## **Bridgwater Tidal Barrier Scheme**

### **Short List of Options – Consultation Response**

FINAL

December 2016

Figure 1 – Location of short listed barrier sites

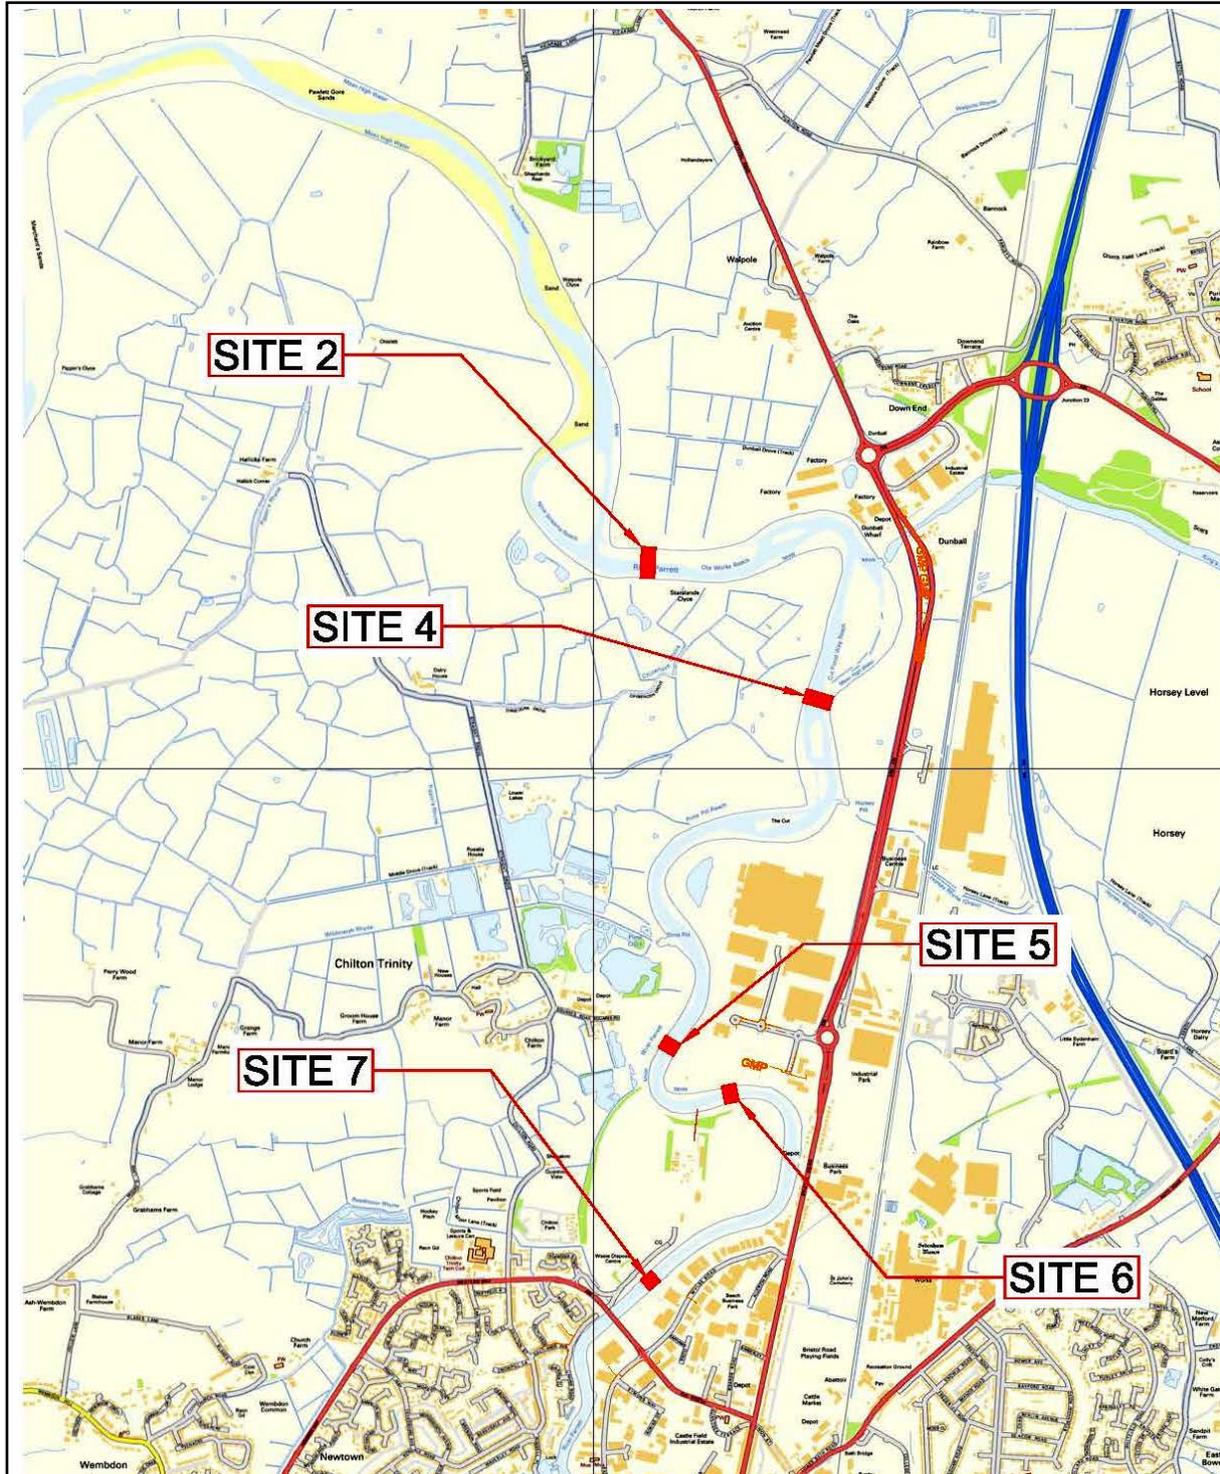
- Would bring additional economic benefits to the town;
- Would provide more opportunities for development along Bristol Road and to the west of the river;
- Provides a better opportunity for a future road crossing;
- Provides the most storage capacity to avoid flooding upstream;
- Better for traffic flows in Bridgwater;

- A good balance between cost and benefits;
- Site 4 has the potential for silt build up at Dunball Wharf;
- Least impact on navigation;
- Less environmental impact, easier access routes for construction and less cost.

- A vertical lift gate would be more visually intrusive than a rising sector gate;
- Site 5 would have less visual impact but Site 4 could be made a special feature in the landscape;

- Focus on environmental enhancement rather than just mitigating loss;
- Site 2 would be better as it provides better protection to businesses at Dunball Wharf;
- Barrier should incorporate tidal power generation;
- Proposals lack any long term vision;
- Potential to impact on archaeology;
- Need to understand impact of Site 4 on operations at Dunball Wharf.

Our assessment is that although there are some advantages associated with Sites 2, 6 and 7, these are outweighed by the disadvantages and that overall, Sites 4 and 5 are preferred.

Site 2 is not taken forward largely because of the size and likely cost of the structure required and the potential impact on navigation to Dunball Wharf. It also has the greatest overall environmental impact of the short listed sites.

Site 6 could impact on discharge from Chilton Trinity sewage treatment works immediately downstream due to increased water levels potentially requiring modifications to the treatment works and could result in disturbance to a former tip site on the south bank requiring disposal of contaminated material. Site 6 is similar in nature to Site 5 but has the disadvantages described above which do not apply to Site 5 and it is therefore not taken forward.

Site 7 is close to the town and construction would have a significant local impact, it would be difficult to improve defences downstream and there is not sufficient storage volume in the channel upstream. It is therefore not taken forward.

Site 4 is a large barrier but could minimise overall flood risk to north Bridgwater, maximising opportunities for future growth. There are no space constraints to construction and there is a large storage volume in the channel upstream. The estimated total project costs are £65-80 million.

Site 5 has no major disadvantages except the proximity to commercial development at Express Park and residential development at Chilton Trinity. It would work effectively for flood risk management and we consider that the environmental impacts can be mitigated. The estimated total project costs are £45-60 million.
